Sid Commons Apartment FEIR
Running Errata as of January 27, 2020

This Errata provides clarification on formatting and minor corrections to language and information presented in the FEIR. These changes are for clarification purposes only and do not change the analysis or conclusions of the FEIR.

Project: Sid Commons Hydraulic Evaluation

Subject: 100-year Flood Boundary
Post-Processing

City of Petaluma
100-Year Flood Boundary
Effect of Sid Commons Terracing
Sheet 1 of 2

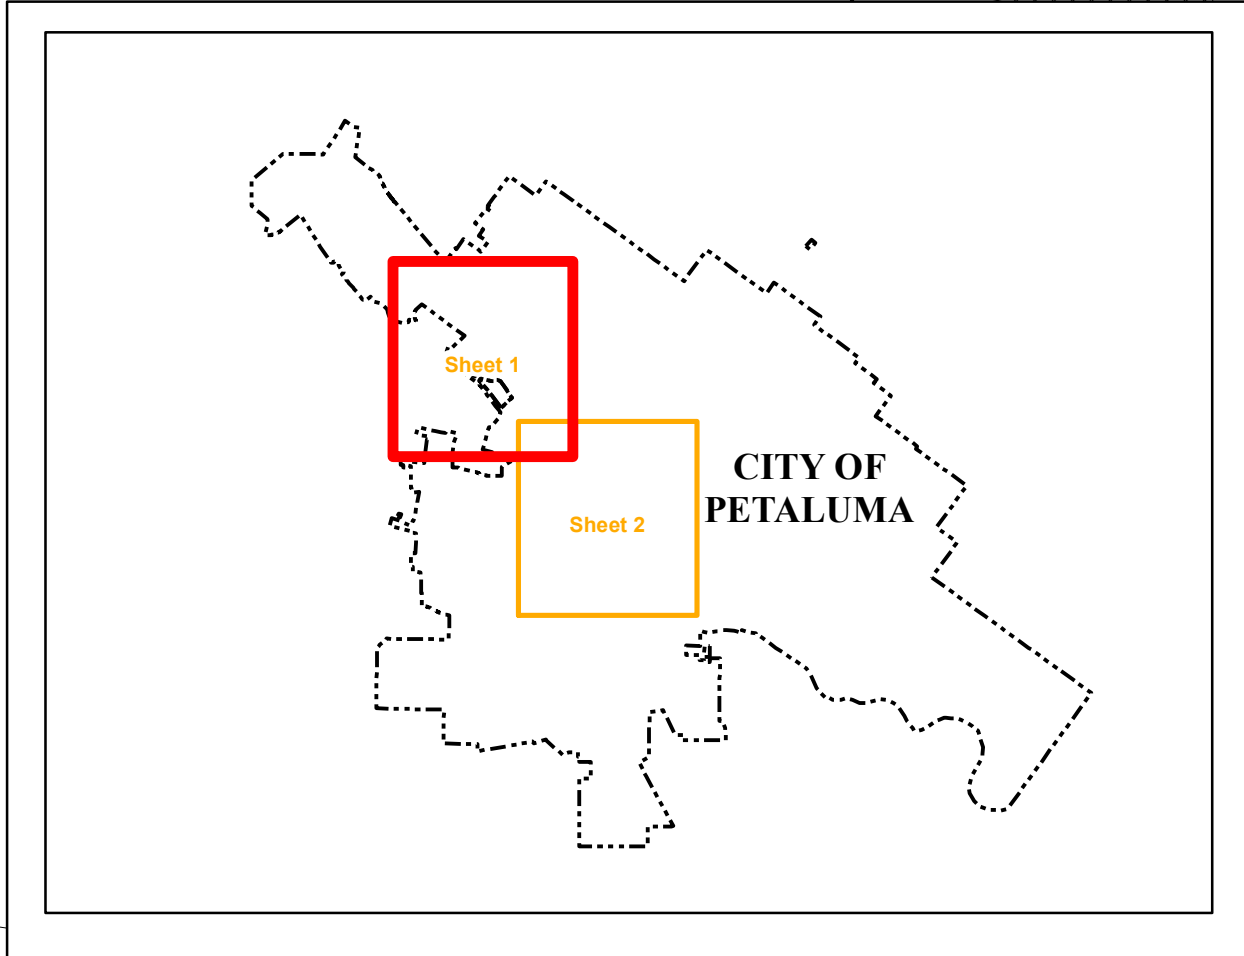
The City has requested this addendum to the WEST 2017 memo to address the 100-year event graphics as described above. The revised graphics with the described post-processing are included as Attachment 1. Areas that were previously mapped behind the floodwall for the 100-year event downstream of the constriction weir (left and right overbank) are not at risk of flooding for the following conditions: existing conditions, proposed conditions with the Sid Commons development, or proposed conditions with cumulative future detention and/or terracing elsewhere in the City. The revised

mapping shown in Attachment 1 does not change previous summary data summarizing the effect of terracing and detention providing a 25% decrease in the flood boundary (180 acres).
